Crete Nursery, Dappers Lane, Angmering, West Sussex

Arboricultural Method Statement ADDENDUM

Produced on behalf of Countyoak Homes Ltd on
08/11/2019

Plate 2: Garden & Boundary Fences

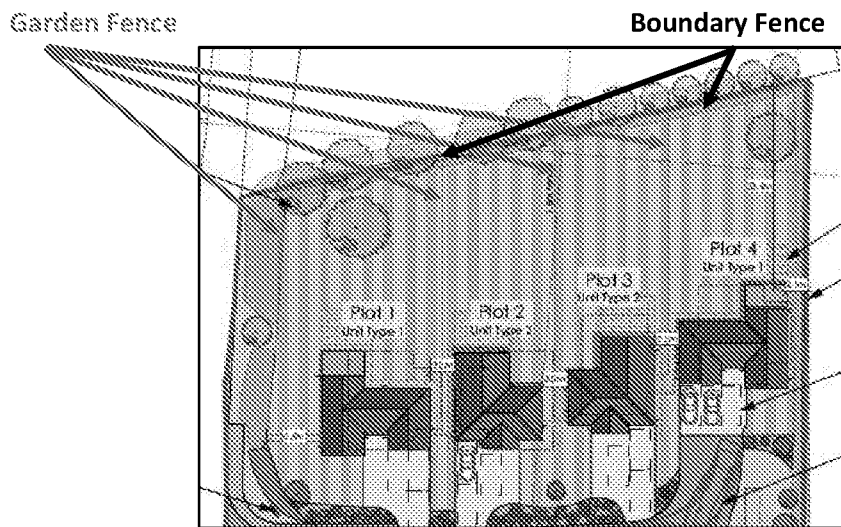
- 1.4 Paragraph 3 states *'The AMS does not cover in enough detail what is happening with the boundary fencing and garden division fencing within the RPA of the hornbeam trees to the north and off-site – mitigation measures and methodology required here.'*

- 2.2 The development proposals require the construction of small fences (1.8m high) to delineate the gardens of each plot and the northern boundary of the site (see Plate 2). The boundary and garden fence will be comprised of closeboard panels and posts, the posts will require digging within the RPA of the hornbeams.

- 2.4 The garden fence (see Plate 2) will be constructed using 1.8-metre-wide panels with supporting fence posts. This will require digging a maximum of three gate posts per fence line to be dug within the RPA of the line of hornbeam to the north of the site. The holes for the fence posts will measure L: 0.2m x W: 0.2m x D: 0.5m.

Plate 4: RPA of T07 in Relation to the Existing Hardstanding Access Track
Dominant Category A Oak Tree (T07) With 9.15m RPA Superimposed

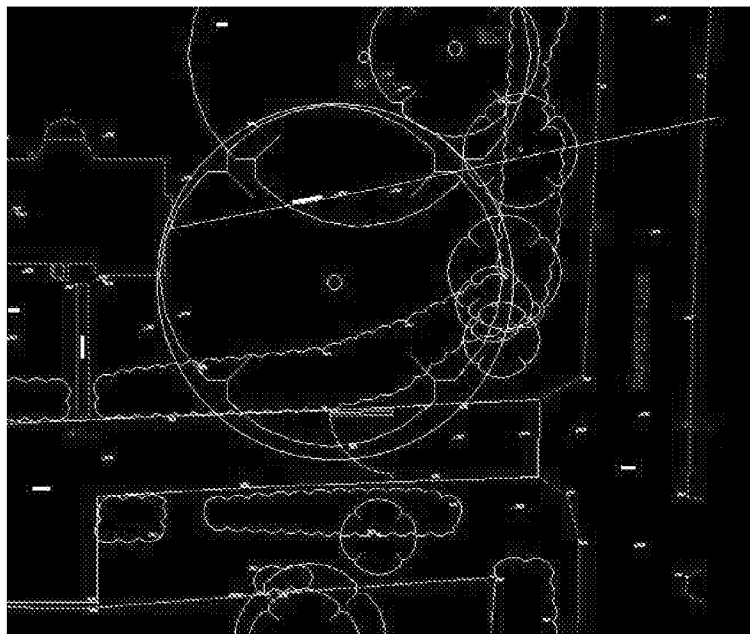
- 1.5 Paragraph 4 states that *'The AMS does not detail exactly what is happening and the mitigation measures and methodology required here for any revisions to the access drive (widening or resurfacing) that appear to be taking place.'*

- 3.2 The removal of the existing hardstanding track will be undertaken using the '*break up, pull back*' principle. The pieces of concrete will be taken out by hand and placed outside of the area of concern. The subbase will be taken out using a mini digger stationed on the remaining hardstanding to ensure roots do not become compacted.

- 3.5 The southern extent of the replacement road will follow the line of the existing track and will not extend further toward the dominant Category A oak (T07).

- 3.6 The RPA of T07 (9.14m) will be measured and marked-out using fluorescent spray paint, where it extends underneath the existing hardstanding access track, to identify the area of concern to all site users. This will be undertaken at the earliest possible convenience following full planning permission being granted. The marked-out area will conform broadly to that highlighted in the bottom picture of Plate 4. The line will be suitably annotated to clearly signify what it is marking out, the hardstanding outside of this line can be removed without the supervision of an arboricultural watching brief.
